Address: 715 Atlantic Avenue

File Number: 8-A-20-IH

Infill Housing Overlay Staff Comments & Recommendations

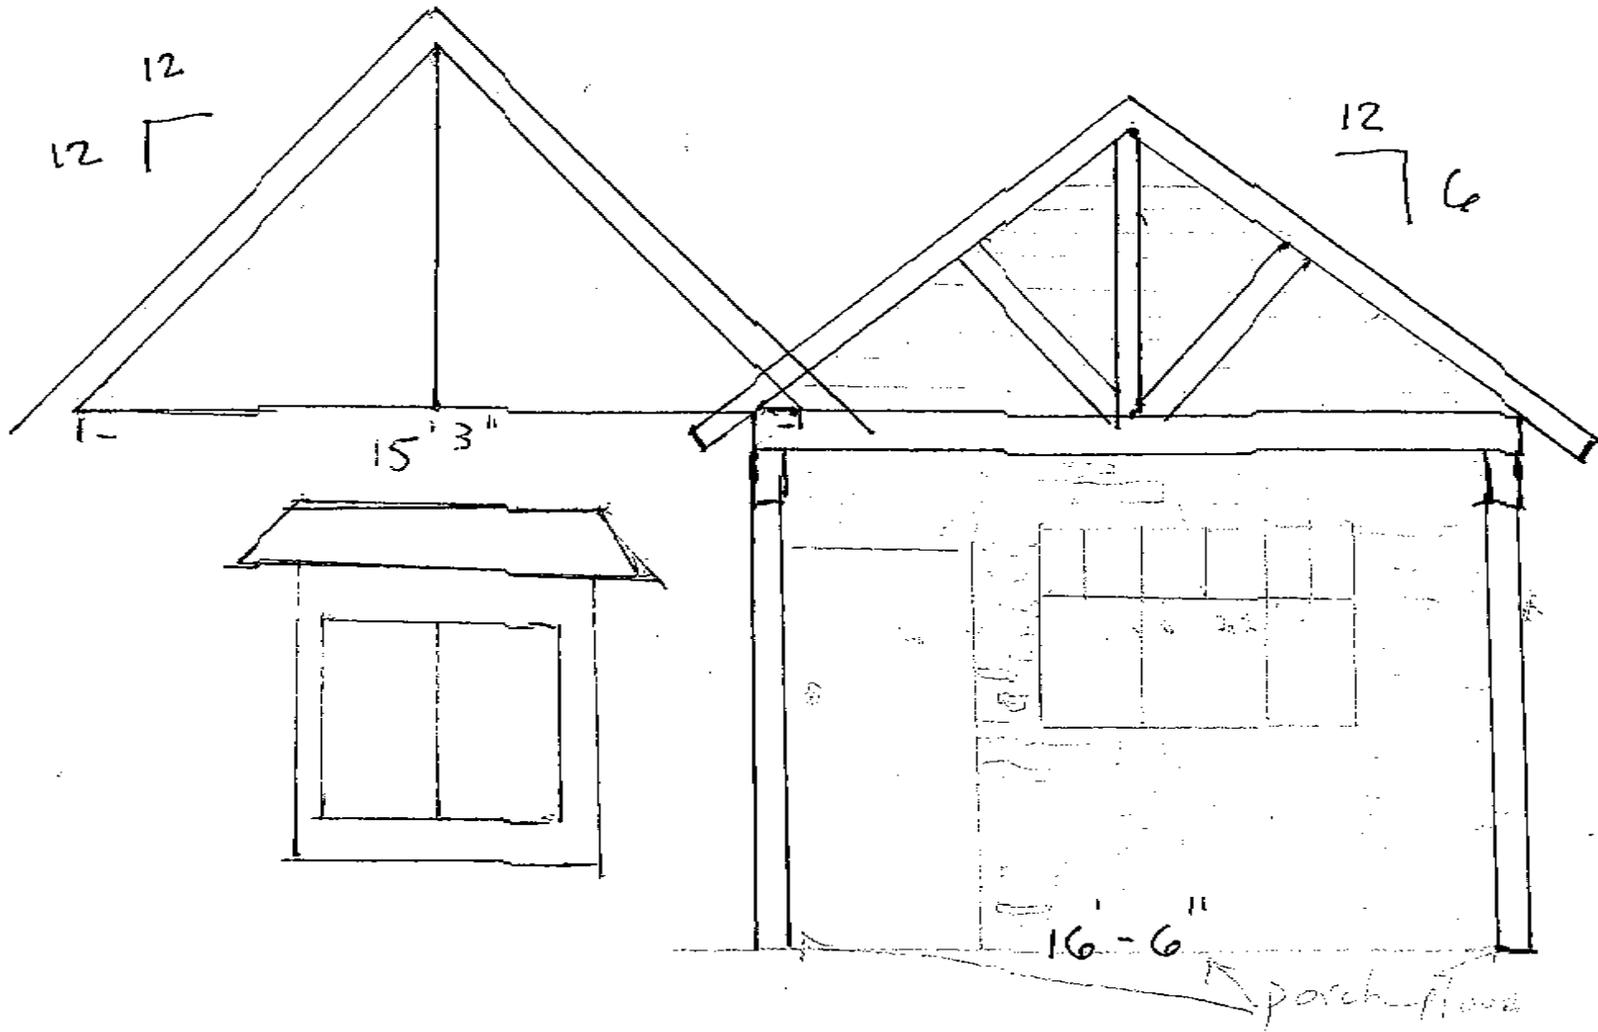
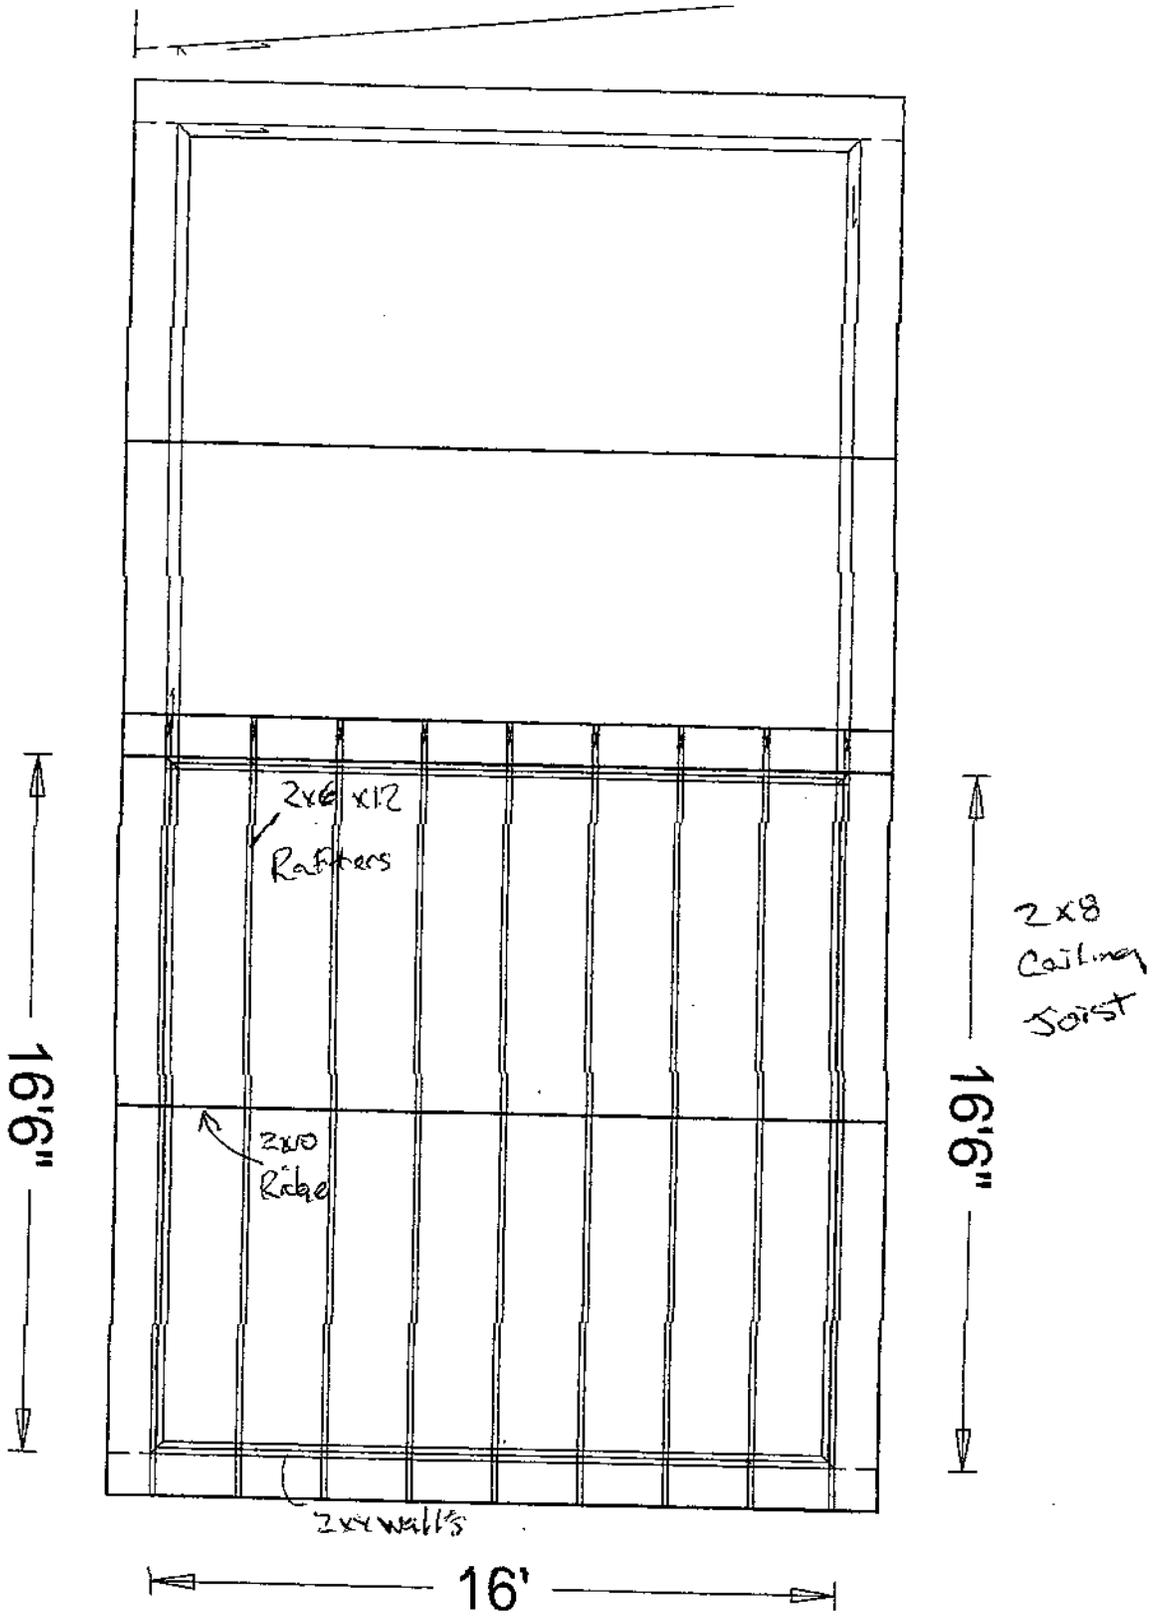
1. The application meets the Infill Housing Review Design Guidelines for porches and stoops (p.9).
2. The applicant is proposing an open gable on the porch façade. The Committee has approved this design in the past, and also encouraged applicants to enclose open gables with siding to better resemble historic porch designs.

2. The previous porch was a stoop, covered with a shed-roof metal awning, characteristic of mid-twentieth-century porch design.
3. The proposed scope of work includes replacing the flat-roof enclosed section with a front-gable roof which extends towards the street to provide a front-gable roof porch. The new roof has a 6/12 slope and incorporates eave overhangs on the side elevations.

4. The roof modifications do not expand the footprint of the front porch.
5. The applicant proposes to complete the project with 6" x 6" square wood posts and an open gable with diagonal cross bracing (or a "wagon wheel" design). The Committee has both approved open gable porch roofs and encouraged the use of siding on porch gables to better resemble historic porch designs.

Staff recommends approval of the project as submitted.

1. The project restores a front porch which is more proportional to original houses on the block (p.9).
2. The new porch design involves replacing non-historic metal columns with wood posts, which are more in keeping with historic porch materials (p.9).
